Glanmire Solar Farm – Response to Commission’s Questions on Notice

The Commission is seeking information on the following three matters regarding the State significant development application for the Glanmire Solar Farm (SSD 21208499) (Application), currently before the Independent Planning Commission (Commission) for determination. Please find our responses below:

Glanmire Solar Farm Indicative Site Layout Plan

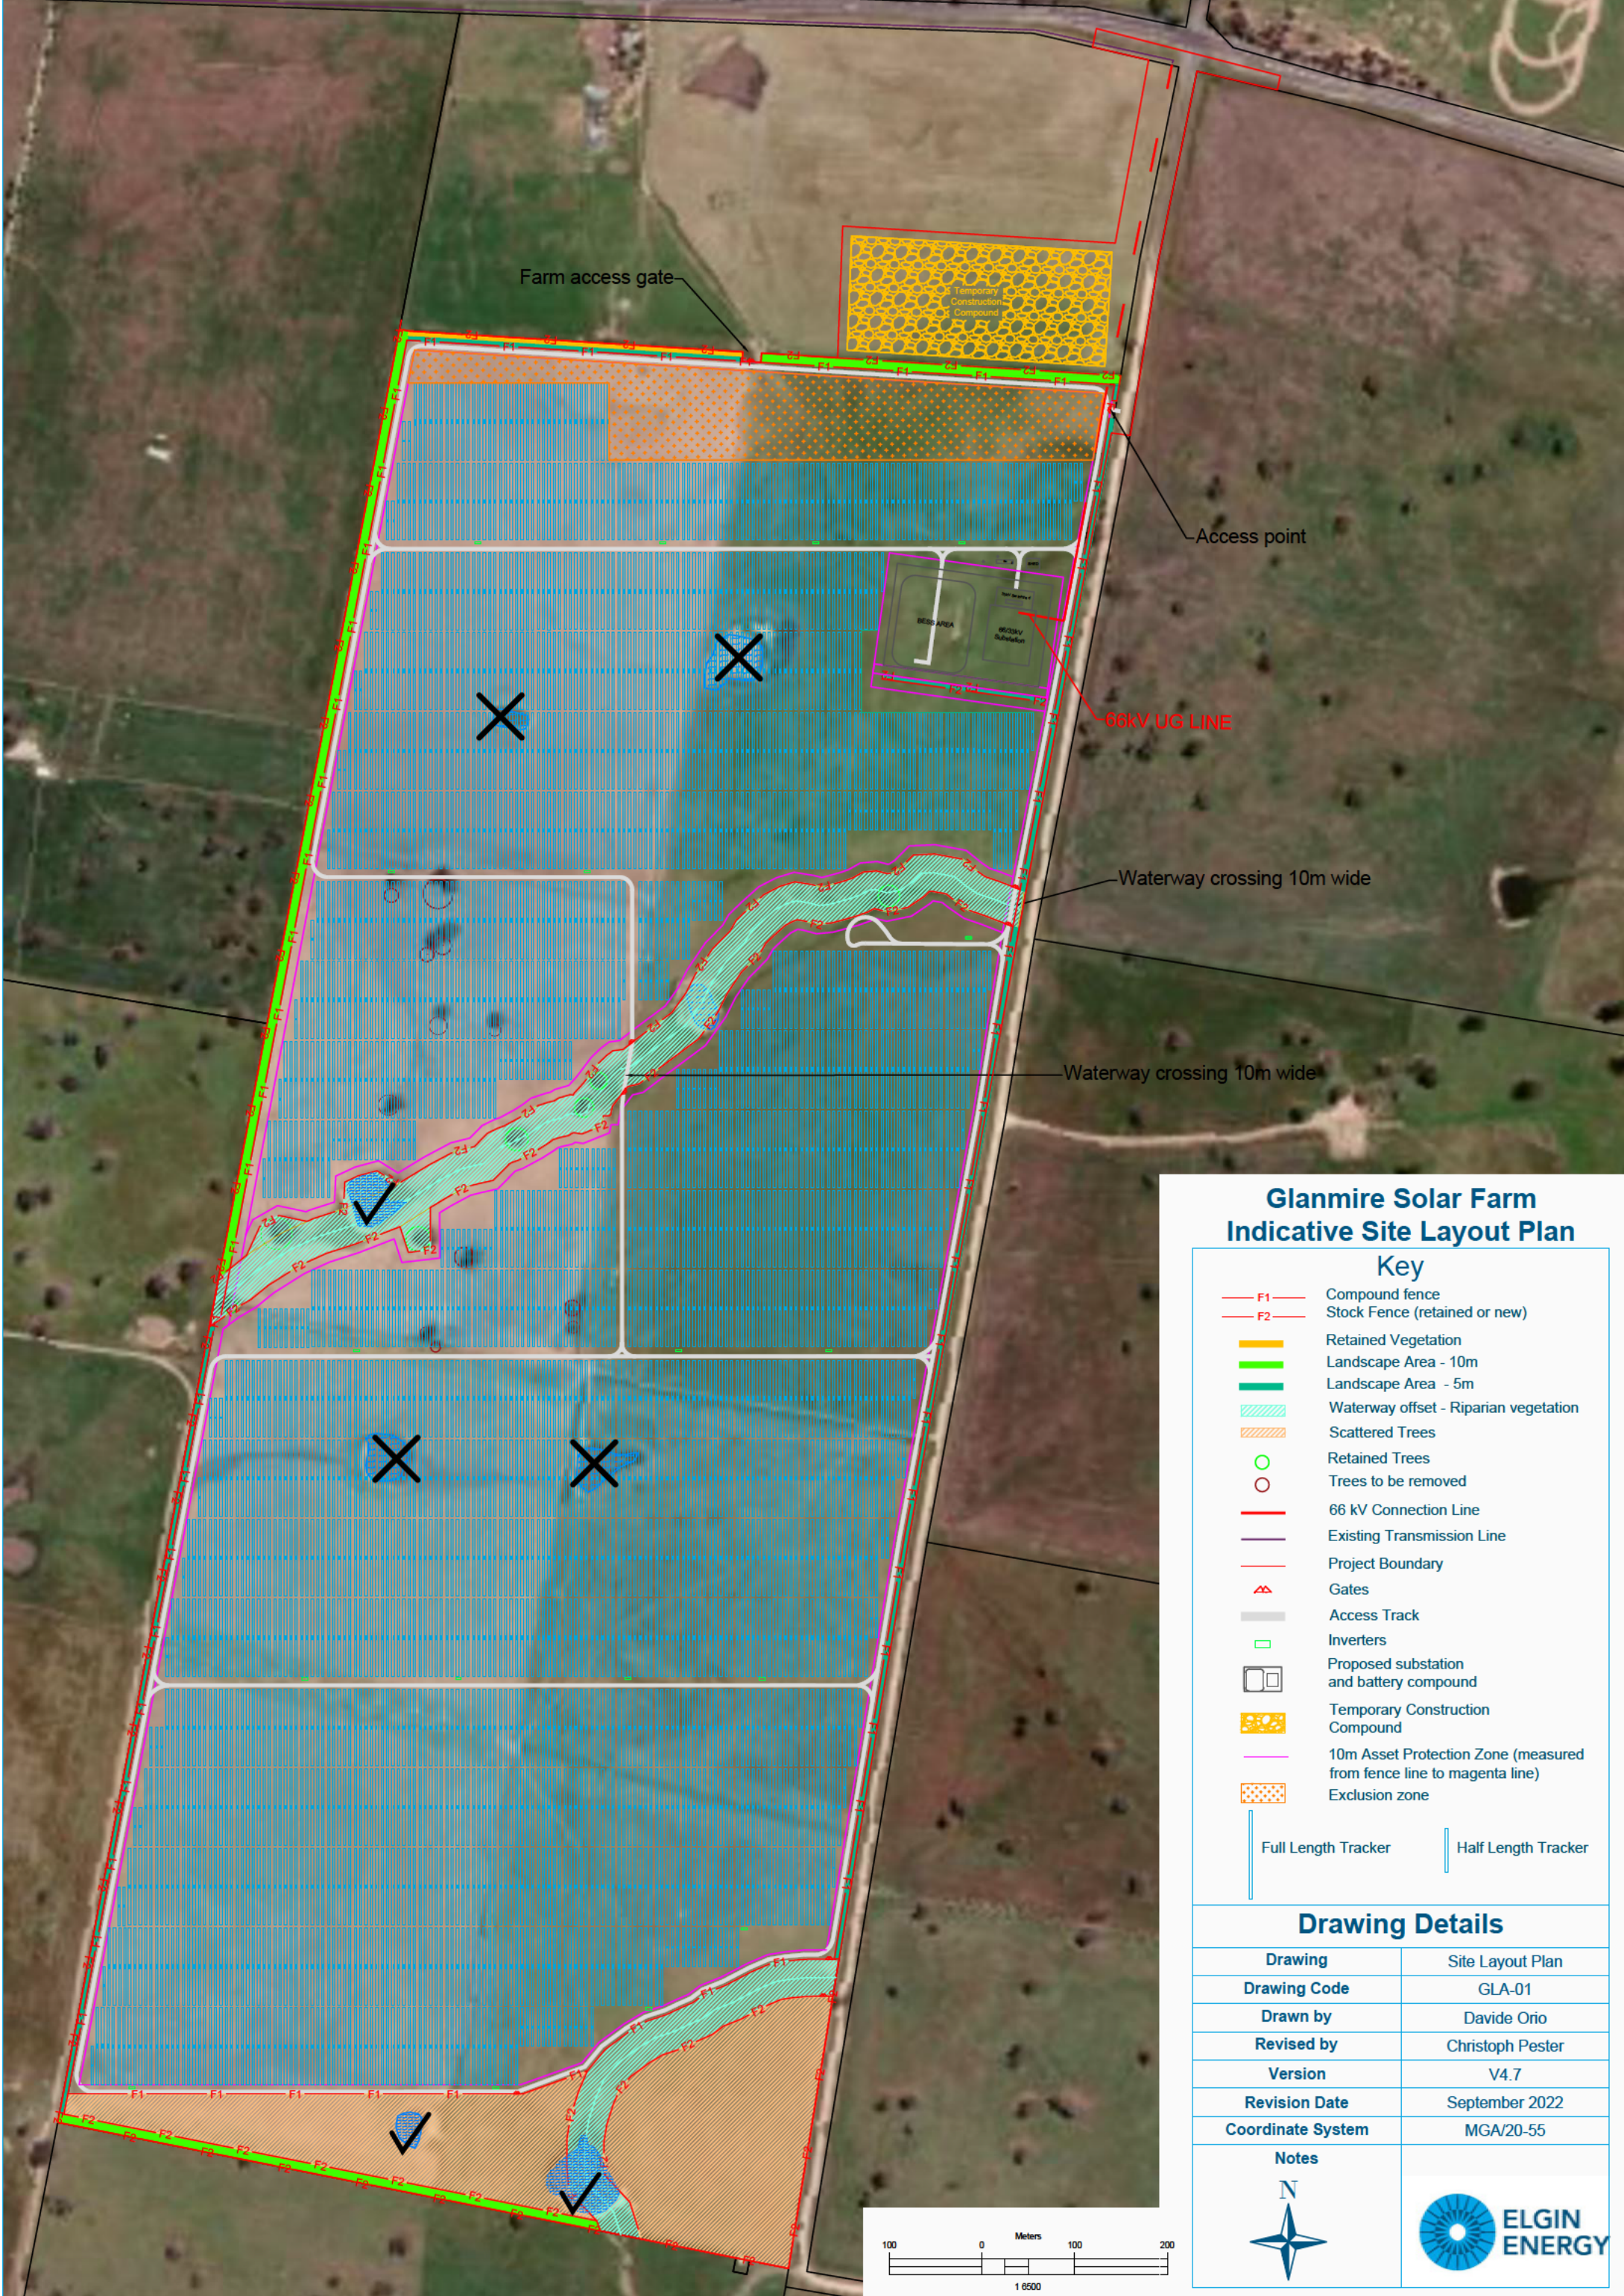
1. Please specify which dams will be infilled and which will be retained as part of the Project. The Commission would be assisted by a plan demonstrating this.

Please find a map attached for demonstration. There are four dams to be infilled (marked with an ‘x’) and three to be retained (marked with a ‘√’) as part of the Project. This is in accordance with the indicative layout; the detailed design may result in some changes, so long as the result remains consistent with the assumptions of the assessment and consent.
